General Inquiries

Inquires for Boulder & Larimer

Inquires for Osborn & Caywood

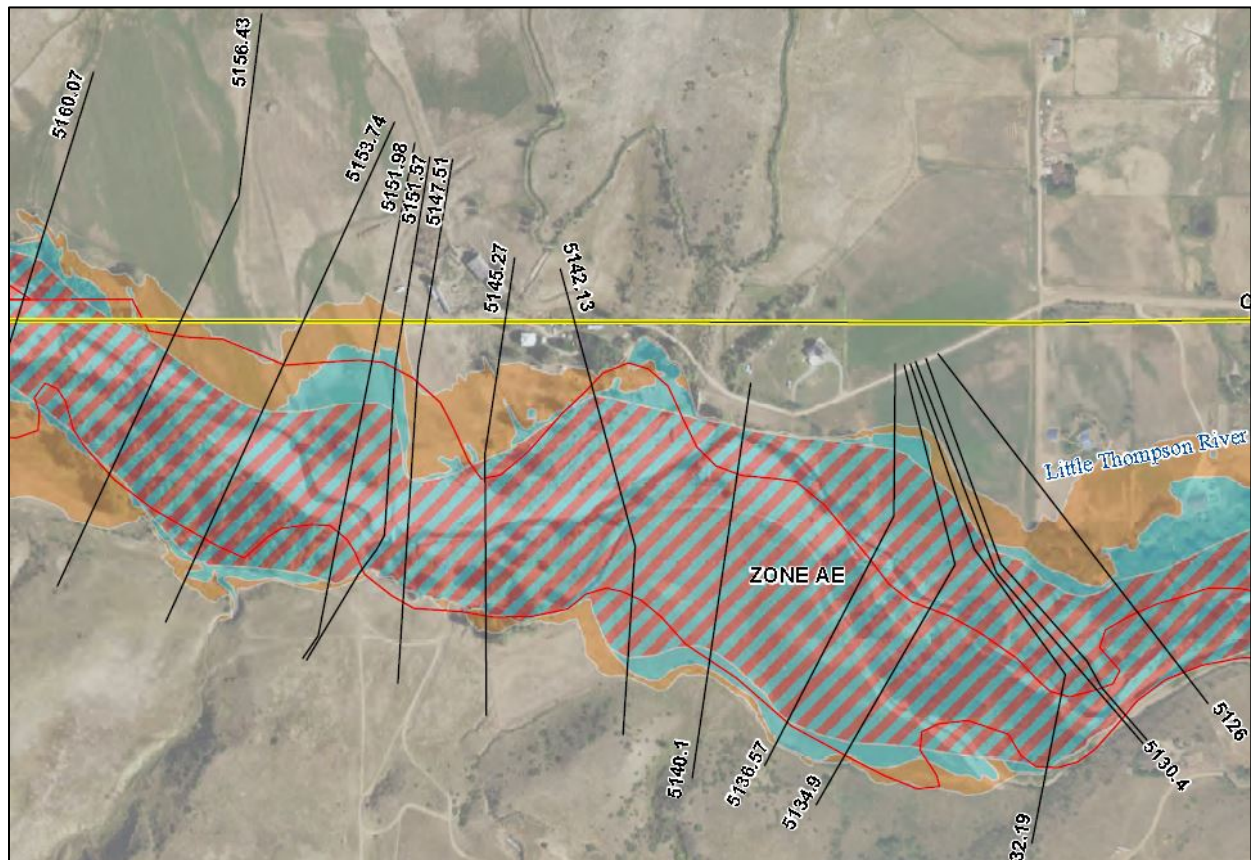
Q: Please confirm to which elevations the "No-Rise" certification must conform. The existing FEMA FIS, and associated Base Flood Elevations, are from the pre-flood model (effective 12/18/2012).

A: The illustration below is an excerpt from map panel 1368 of the recent CHAMP floodplain analysis dated January 20, 2017. Although this information has not been officially approved by FEMA, it is the best base flood elevation data available to date. The complete set of maps can be downloaded from the CWCB Colorado Hazard Mapping & Risk MAP Portal. The Y1 Big Thompson HUC-8 Hydraulics TSDN at <http://coloradohazardmapping.com/hazardMapping/floodplainMapping/Documents>

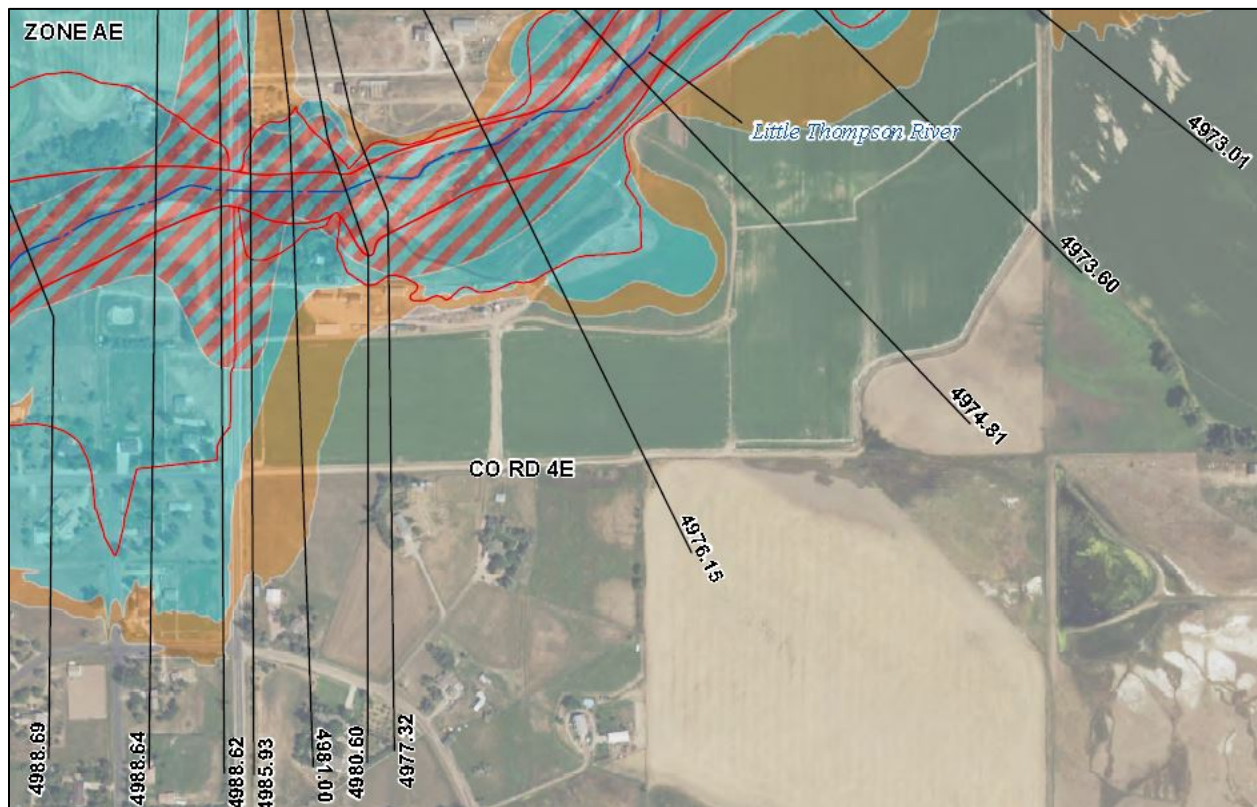
Q: Please confirm to which elevations the "No-Rise" certification must conform. The existing FEMA FIS, and associated Base Flood Elevations, are from pre-flood model (effective 2/6/2013).

A: The illustration below is an excerpt from map panel 1389 of the recent CHAMP floodplain analysis dated January 20 2017. Although this information has not been officially approved by FEMA, it is the best base flood elevation data available to date. The complete set of maps can be downloaded from the CWCBC Colorado Hazard Mapping & Risk MAP Portal. The Y1 Big Thompson HUC-8 Hydraulics TSDN at <http://coloradohazardmapping.com/hazardMapping/floodplainMapping/Documents>
